SUBJECT: MCGUIRE NUCLEAR STATION, UNIT 1 – RELIEF 09-MN-002, REVISION 1,
FOR A PROPOSED ALTERNATIVE TO DELAY THE UPDATE TO THE CODE
OF RECORD FOR THE FOURTH 10-YEAR INSERVICE INSPECTION (ISI)
INTERVAL (TAC NO. ME4870)

SAFETY EVALUATION BY THE OFFICE OF NUCLEAR REACTOR REGULATION

REPAIR OF BURIED SERVICE WATER PIPING

RELIEF NO. 09-MN-002, REVISION 1

Figure 1 (Example of Code-Compliant Repair)

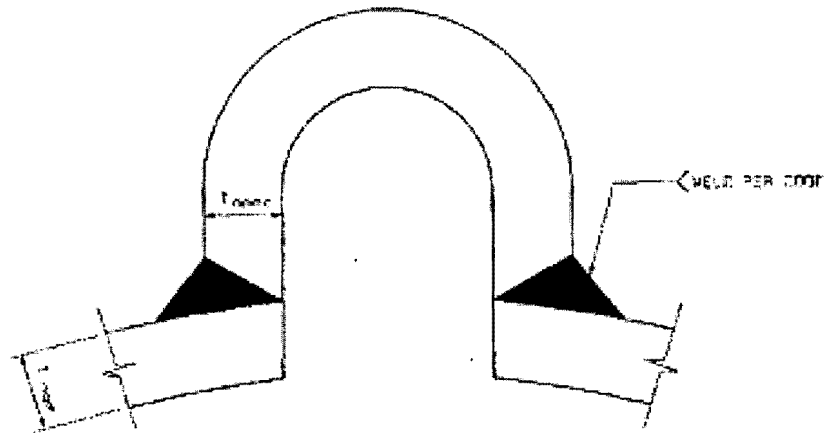
If unacceptable wall thinning is found during the course of an inspection of either the excavated RN LLI or the SNSWP piping, the licensee is required to repair the unacceptable area.* One possible configuration of a Code-compliant repair, where the defect is removed and a new pressure retaining boundary is formed, is shown in Figure 1. In order to perform such a repair, the pipe would have to be isolated, depressurized, drained and the repair would have to be performed, pressure-tested, and examined prior to returning the pipe to service. These activities would have to be performed within the 72-hour allowed outage time for TS 3.7.7, Condition A. If Condition A cannot be met within the 72-hour allowed outage time, both units would need to be in Mode 3 within 6 hours and Mode 5 within 36 hours. The NRC staff concurs with the licensee that isolation, depressurization, draining, defect removal, repair, testing and examination within the 72 hours is difficult. The NRC staff finds that a mid-cycle shutdown of one unit in order to perform a Code-compliant repair would present a hardship.

The NRC staff notes the general design similarity to a Code-compliant repair, Figure 1. The NRC staff finds that the proposed design has several advantages over the Code-compliant repair of Figure 1. First, the application of corrosion protection within the encapsulation after pressure testing inhibits corrosion on the interior of the encapsulation as well as the remaining pipe wall within the bounds of the encapsulation. In addition, the remaining pipe wall material, while performing no structural function, provides an additional corrosion allowance in comparison to the design configuration of the Code-compliant repair (Figure 1). The NRC staff concludes that the proposed alternative encapsulation design is acceptable.

Figure 2 Example of Repair/Replacement Conforming to Proposed Alternative

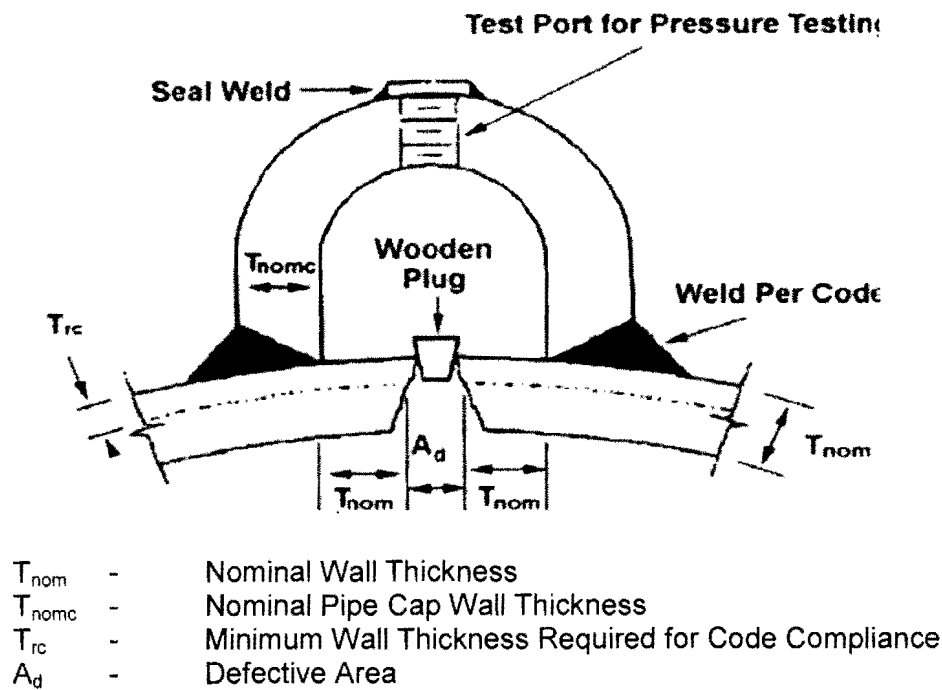
The licensee has proposed an alternative repair in which excessive localized wall thinning or through-wall leakage resulting from internal or external corrosion is repaired by encapsulation on the outside of the pipe without removing the defect (Figure 2). The encapsulation for both ID- and OD-initiated unacceptable wall thinning will utilize a pressure retaining encapsulation, not to exceed 10-inch NPS, that complies with Construction Code and the Owner's requirements, and the spacing between encapsulated defects will comply with Construction Code design limits. The licensee has set the minimum inside diameter of the encapsulation to be the maximum diameter of the defective area plus twice the nominal wall thickness. Based on the licensee's specific plant history of general corrosion and pitting corrosion rates, the NRC staff finds this dimension is adequate to provide reasonable assurance of structural integrity and leak tightness for the projected life of the repair.

The weld between the encapsulation and pipe will be an ASME Code-compliant weld. The NRC staff notes that the pipe material (P-1) and wall thickness (0.5 inches) does not require either weld preheating or post-weld heat treatment. However, the pipe wall being welded will be water backed. Welding on water-backed pipe is not addressed in Section III or Section XI of the ASME Code, and is an essential variable only for temper bead welding procedures, but could become an issue when the base material has high hardenability. In response to the NRC staff's Requests for Additional Information (RAIs) (References 2 and 4), the licensee noted that the piping is carbon steel, A-134 Grade 283C, SA-155 Grade C55, SA-285 Grade C or SA-155 Class 1 Grade KC70, and is low hardenability and not susceptible to production of a hard, brittle microstructure in the heat affected zone. Furthermore, the licensee stated that a stringer bead weld technique that is expected to produce tempering in the heat affected zone will be used. In addition, the licensee will perform a surface examination of the weld after waiting at least 48 hours to allow for the possibility of delayed cracking. The NRC staff finds that the licensee's procedures for welding on, and examination of, a weld on a water-backed surface is acceptable.
